Re: Variance Application of **Horizon Atlanta Outlet Shoppes, LLC**
V # 101-11

The Woodstock Planning Commission has asked for additional information regarding the proposed variances and to include potential stipulations that the client would agree to ameliorate the variance requests. Please accept this letter as an answer to the individual questions presented by the Planning Commissioners in previous emails forwarded by Brian Stockton.

THE OUTLET SHOPPES AT ATLANTA - WOODSTOCK, GA

OVERALL SIGNAGE SITE PLAN 1 of 1

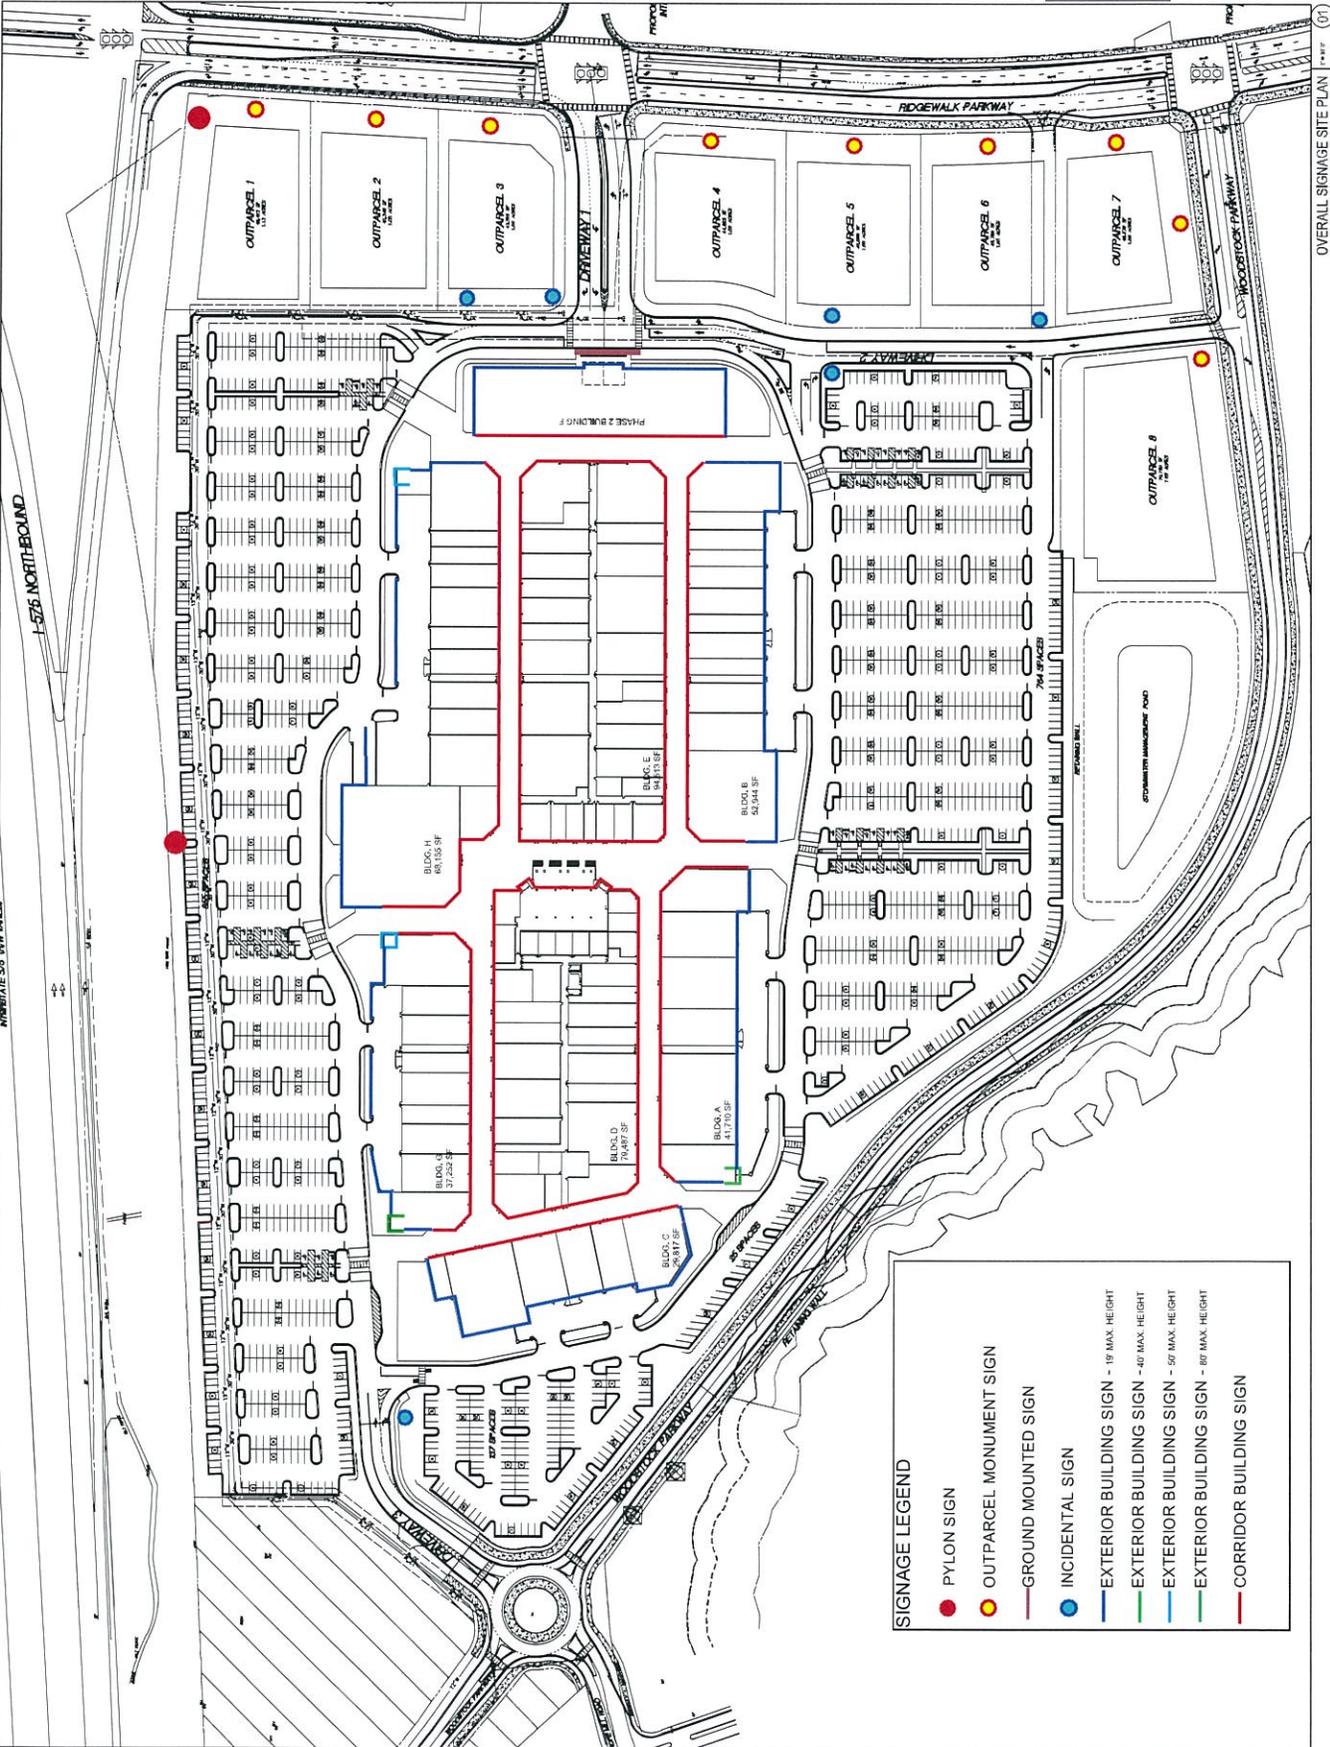
- a. Not specifically addressed in the Sign Standards
- b. Located approx. 300' back from Ridgewalk Parkway (as shown in Exhibit A) at intersection of project entry drive and project loop drive
- c. Intended as entry sign to greet shoppers as they enter the parking area
- d. Max. height based on Monument Sign provisions of Sign Standards
- e. Width matches width of entry drive, approx. 85'
- f. All outparcel and entrance Monument signage will comply with the sign ordinance.

Exhibit B - Pylon Sign

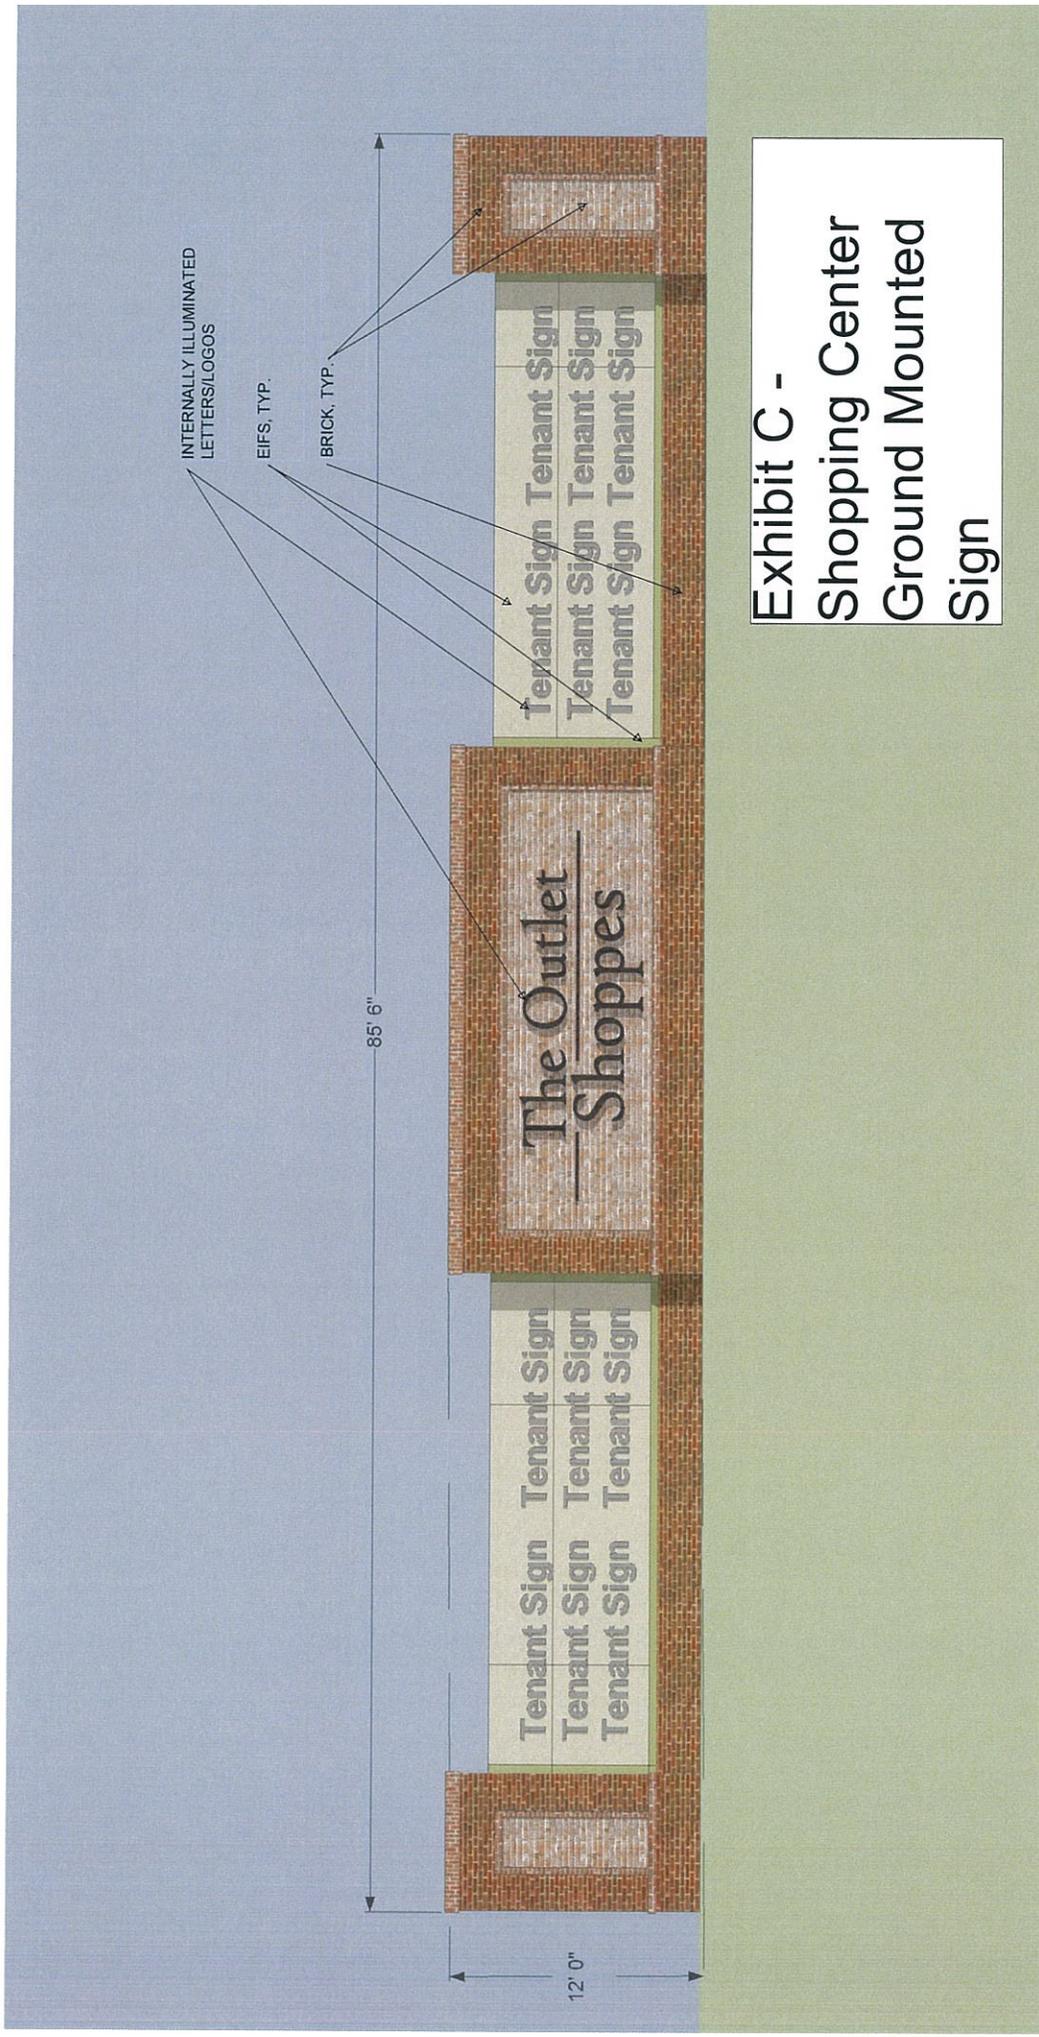
- a. Sign on Outlet parcel shall deviate as follows:
 - a. The sign an additional Eight (8) feet to accommodate a decorative feature.
 - b. Allowable area of copy portion of sign shall be 300 sf instead of to 120 sf.
 - c. Copy portion of one Pylon sign shall include fixed signage and an LED panel as follows:
 - i. LED panel shall be 120sf
 - ii. LED panel shall not include rolling, flashing, or moving text
 - iii. Lumen output of LED sign shall be as agreed between owner and City within reason
 - iv. Time between message changes shall be as agreed between owner and City within reason
